Subject: **WATER AND WASTEWATER CAPACITY AVAILABILITY LETTER**
Ombelle – DRC Case No. UDP-A24024
300 NE 3rd Avenue, Fort Lauderdale, FL 33301

City of Fort Lauderdale
Public Works Department
Water and Wastewater Capacity Analysis

Ombelle – DRC Case No. UDP-A24024
300 NE 3rd Avenue, Fort Lauderdale, FL 33301

Figure 3 – Required Improvements

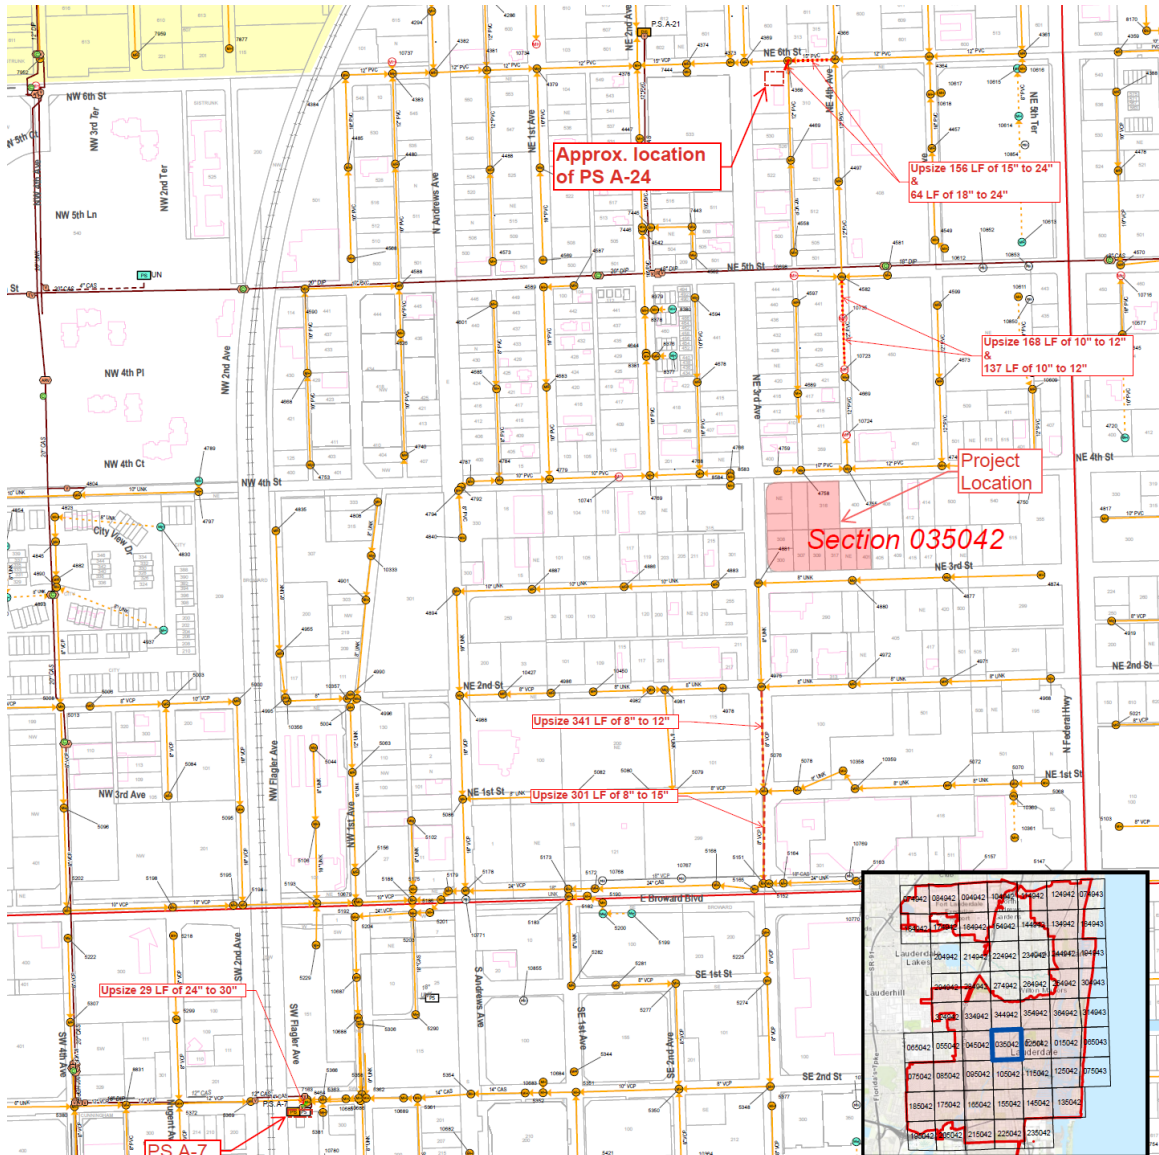
The existing water infrastructure is sufficient and will not require additional improvements, however the existing sewer infrastructure requires improvements to meet the increased demands of the proposed project. See Figure 3: Required Improvements. As previously stated, PS A-7 will also require improvements to support the development and these improvements will take place within the City's CIP project #12899. The improvements shall be constructed, certified, and in operation prior to issuance of any CO.

Evaluation of impact on existing collection pipe: According to the site plan, the applicant is proposing to utilize the 8-inch gravity sewer main to the north of the project site along S.W. 25th Street. Accounting for existing flows and based on the tools and information available to the City staff, it has been calculated that some the pipes downstream of the proposed development will flow higher than the City's governance plan threshold of 70% during peak flows. Therefore, the pipes downstream of the developments are inadequate to serve the proposed project and will require improvements. See Figure 3 for required improvements.

Recommended Wastewater Infrastructure Improvements: In addition to the required PS A-7 improvements, the following wastewater piping upsizing shall be required:

- **Basin A-7**
 - Upsize 341 LF of 8-inch piping to 12-inch
 - Upsize 301 LF of 8-inch piping to 15-inch
 - Upsize 29 LF of 24-inch piping to 30-inch
- **Basin A-24**
 - Upsize 305 LF of 10-inch piping to 12-inch
 - Upsize 156 LF of 15-inch piping to 24-inch
 - Upsize 64 LF of 18-inch piping to 24-inch

The improvements shall be constructed, certified, and in operation prior to issuance of any Certificate of Occupancy (C.O.). See Figure 3 for required improvements.

Figure 4

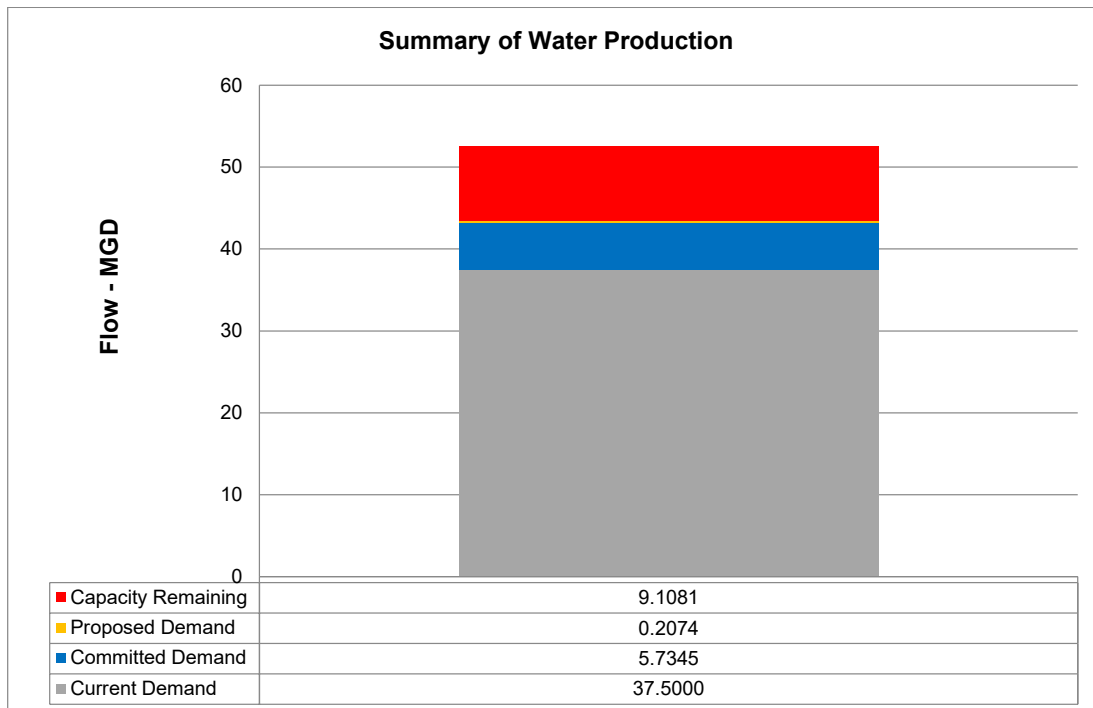
The current twelve-month rolling average production at the two plants is 37.50 MGD. The previously committed demand from development projects in the permitting or the construction stage is 5.73 MGD. Combining these figures with the demand from the proposed project of 0.2074 MGD, the required production would be 43.44 MGD. This is less than the allowable withdrawal limit of 52.55 MGD. Therefore, the water plants have sufficient capacity to serve this project. See Figures 4 below.

Recommended Water Infrastructure Improvements: No improvements required.

Figure 5A: PS A-7

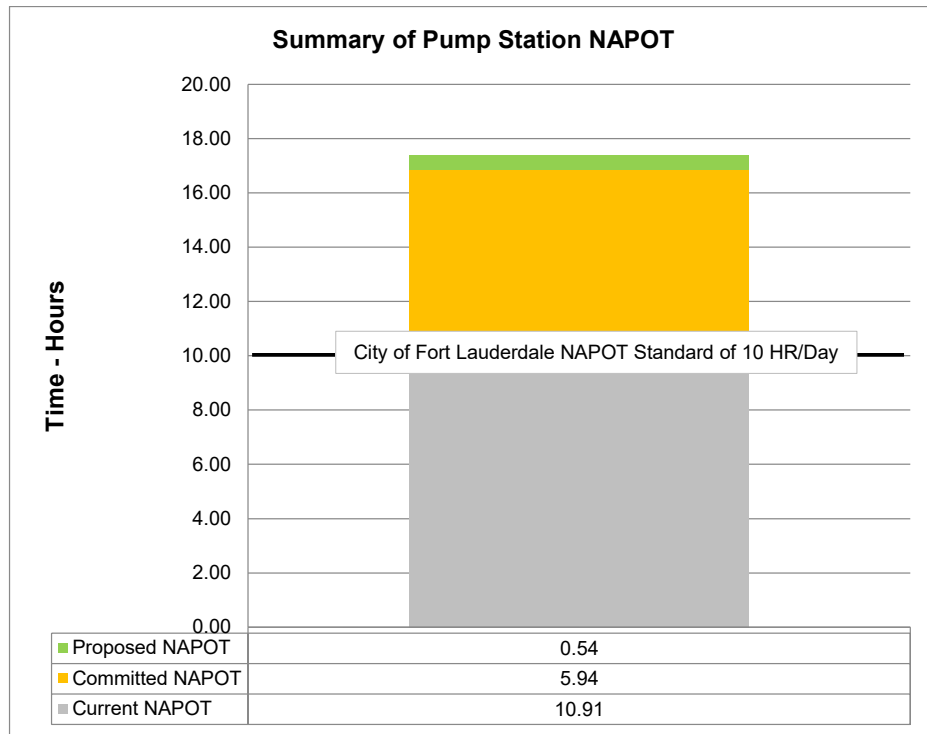
Evaluation of impact on pumping station: PS A-7 has a duty point of 2200 gallons per minute (GPM) and has a Nominal Average Pumping Operating Time (NAPOT) of approximately 10.98 hours per day. PS A-24 has a duty point of 2200 GPM and a NAPOT of approximately 1.73 hours per day. Based on projected sewage flows, the pumping run times would increase approximately 33 minutes per day per PS. Additionally, there are other committed flows from proposed developments within both basins, resulting in 356.57 minutes of additional runtimes for PS A-7 and 288.87 minutes for PS A-24. PS A-7 will have a NAPOT of 17.39 hours once the proposed developments are complete and PS A-24 will have a NAPOT of 7.08 hours. PS A-7 will have a NAPOT greater than the recommended average of 10 hours per day. See Figures 5A & 5B below.

Figure 6

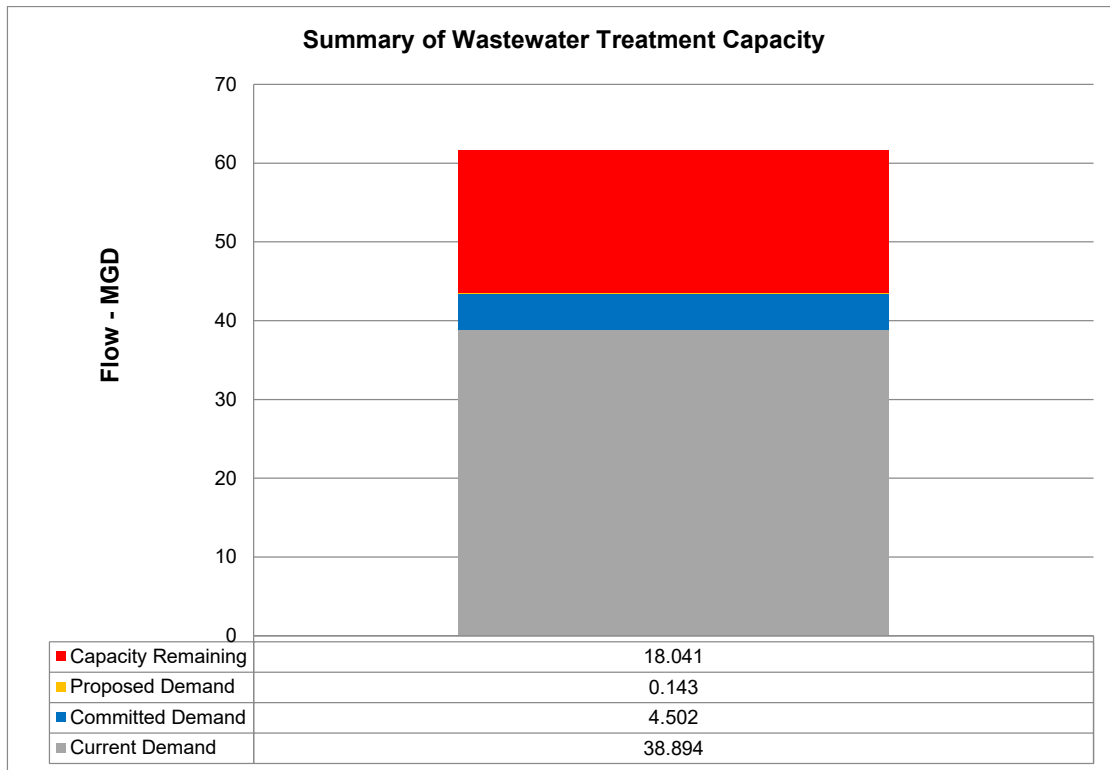
Evaluation of impact of Permitted Wastewater Plant Capacity: The City of Fort Lauderdale owns and operates the George T. Lohmeyer Regional Wastewater Treatment Plant (GTL), which provides wastewater treatment for the City of Fort Lauderdale. The Florida Department of Environmental Protection's (FDEP) permitted capacity for GTL is 61.58 MGD-TMADF (Million Gallons per Day – Three Month Average Daily Flow). The three-month average daily flow (TMADF) to the plant is 38.89 MGD. Combining the committed flows for previously approved projects of 4.50 MGD plus the 0.143 MGD net contribution from the project results in a total projected flow of 43.54 MGD. This is less than the permitted treatment plant capacity of 61.58 MGD. Therefore, the treatment plant has sufficient capacity to serve this project. See Figure 6 below.
